# MULTI - PURPOSE DAM AND RESERVOIR LOCAL PROTECTION

## DETAILED PROJECT REPORT

SUBJECT: Advance Draft - Detailed Project Report for Colebrook Multi-Purpose Dam and Reservoir, Mohawk River, Connecticut River Basin, Colebrook, New Hampshire

3. With reference to paragraphs in your basic letter of 3 December 1964, a copy of which is attached, specific replies to engineering review comments are noted as follows:

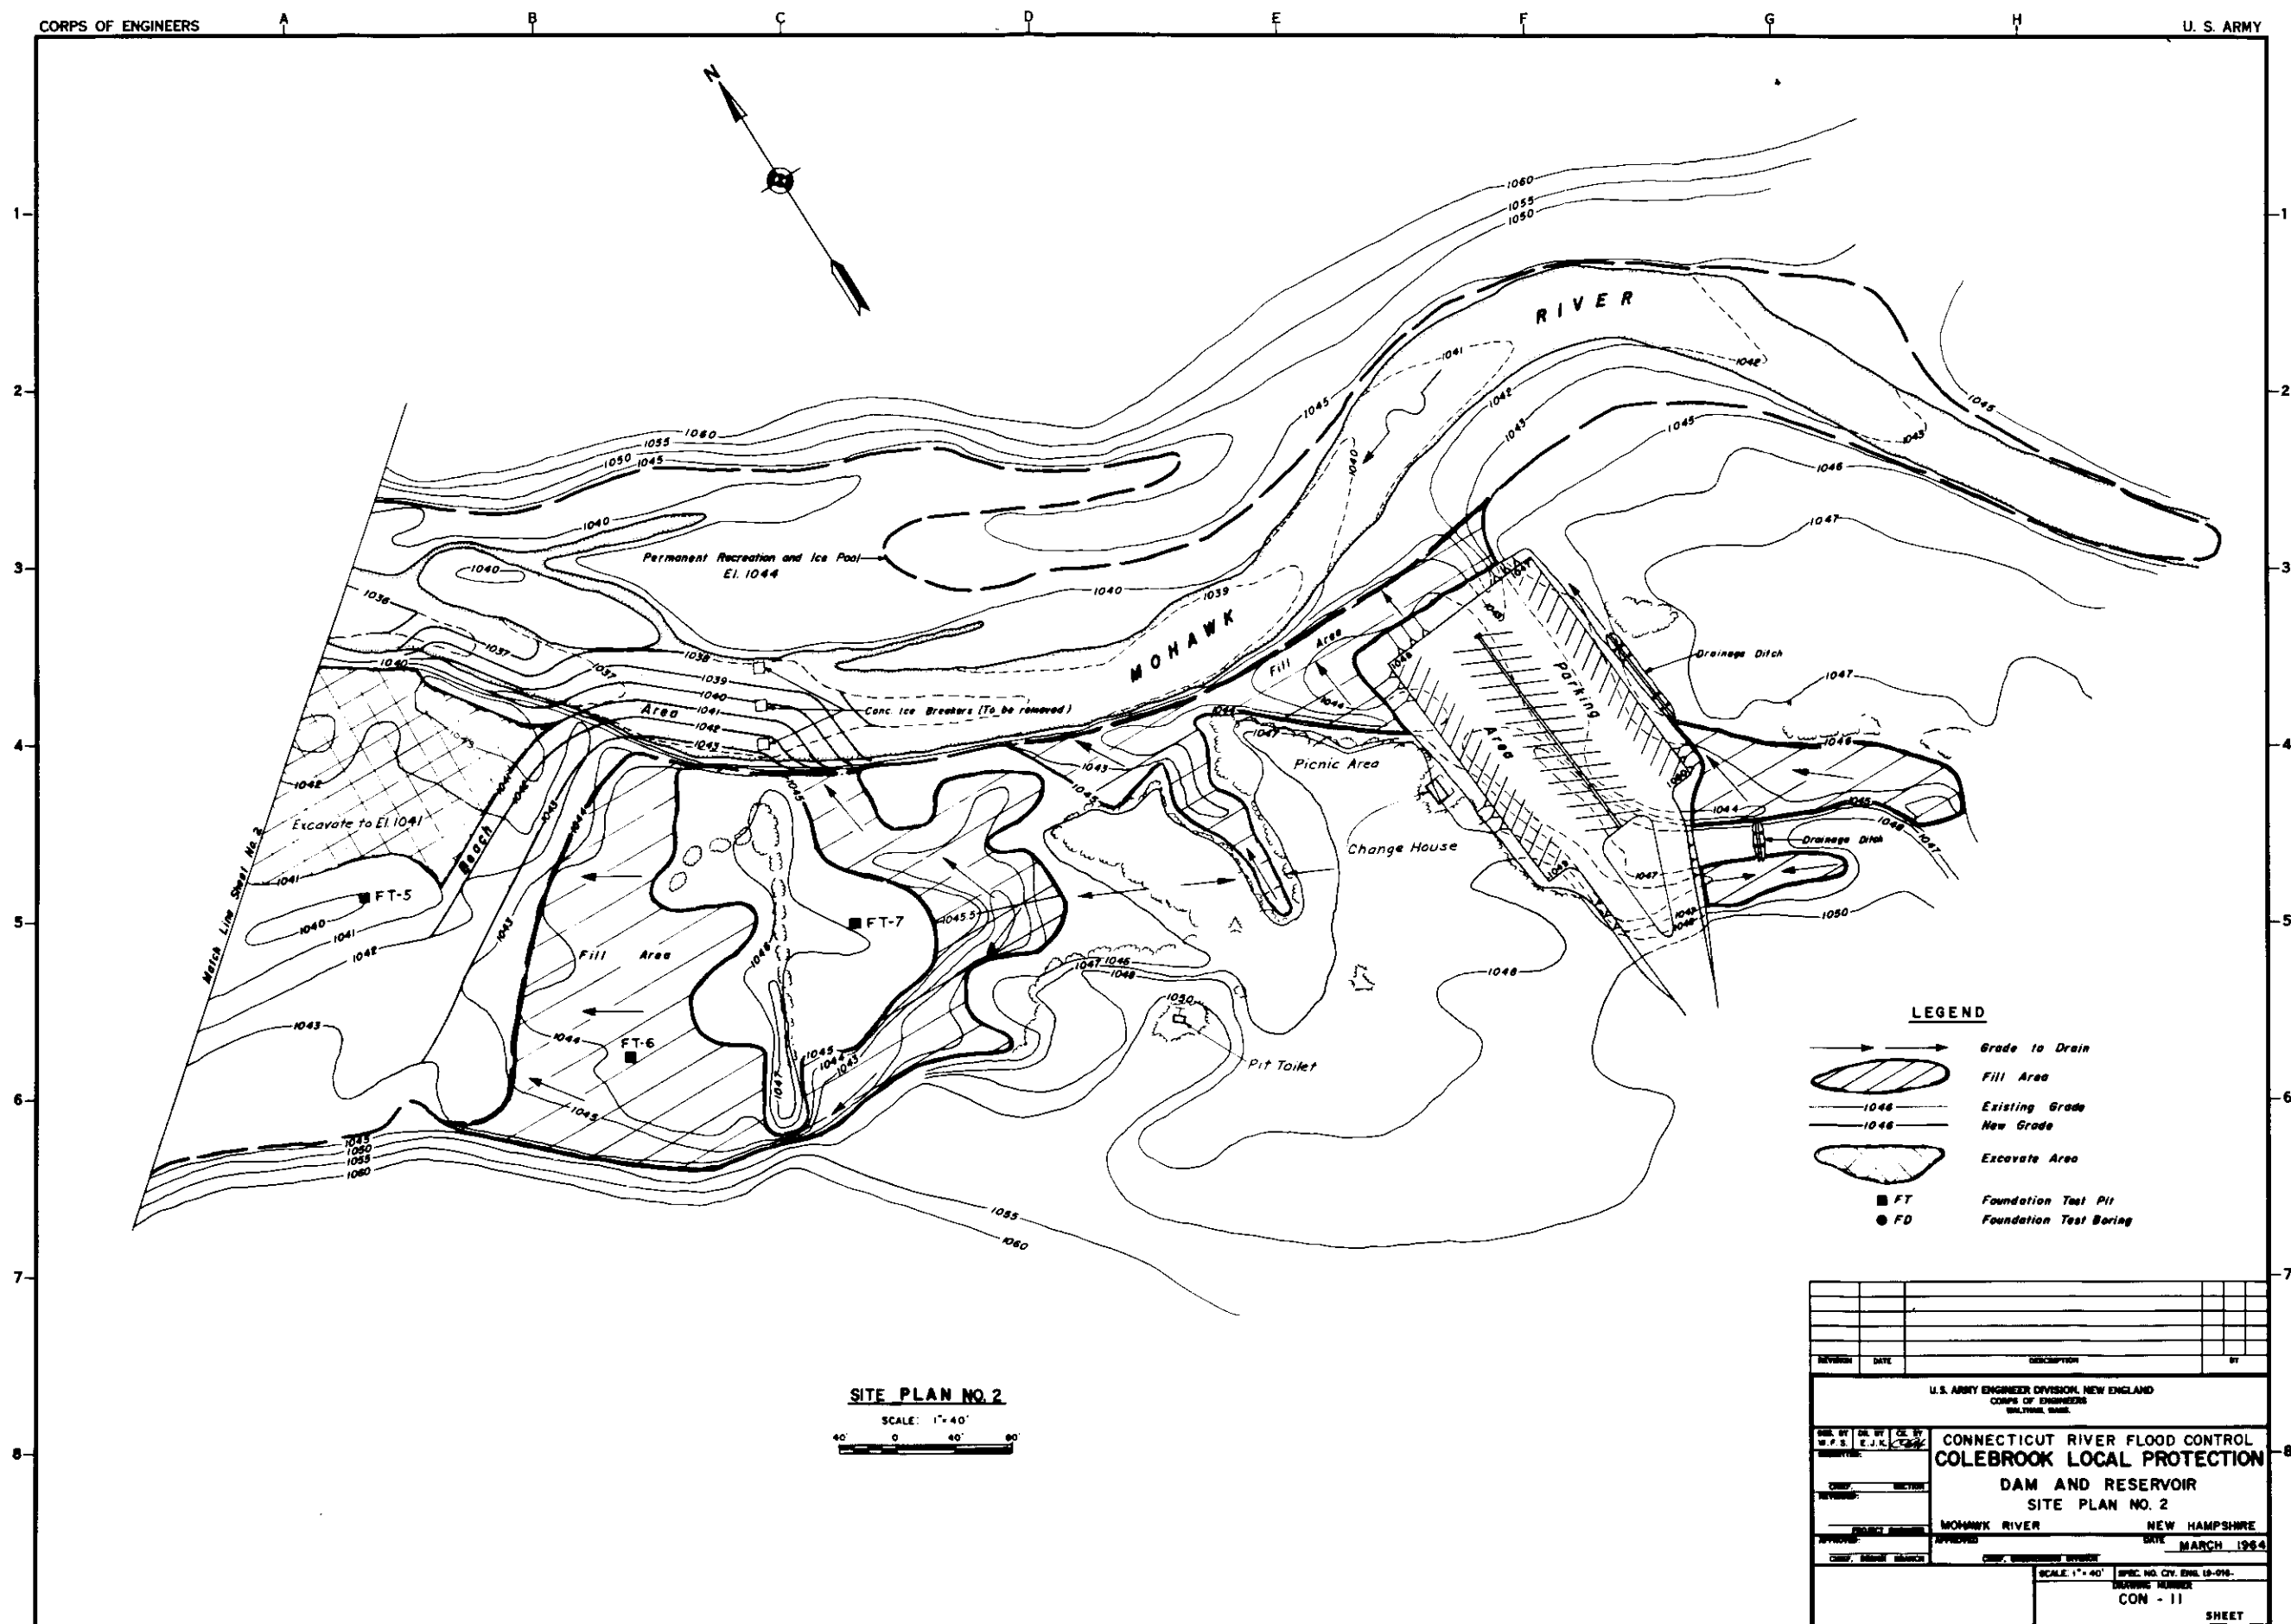
a. Although the proposed structure is low, the foundation is pervious to semi-pervious and no cut-off is provided; therefore, an upstream impervious blanket of an additional 100 feet should be added to both the spillway and embankment.

1a. An upstream impervious blanket of an additional 100' has been added to both the spillway and length of embankment.

REVISION		DATE	DESCRIPTION
1			Scale Impervious blanket revised.
U.S. ARMY ENGINEER DIVISION, NEW ENGLAND CORPS OF ENGINEERS WALTHAM, MASS.			
DR. BY F.W.S.		TR. BY C.W.N.	CR. BY C.W.N.
SUBMITTED		REVIEWED	
CHIEF		SECTION	
PROJECT ENGINEER		MOHAWK RIVER	
APPROVED		NEW HAMPSHIRE	
CHIEF DESIGN BRANCH		DATE MARCH 1964	
SCALE AS SHOWN SPEC. NO. CEN. 10-1018		DRAWING NUMBER	
CON - 11		SHEET
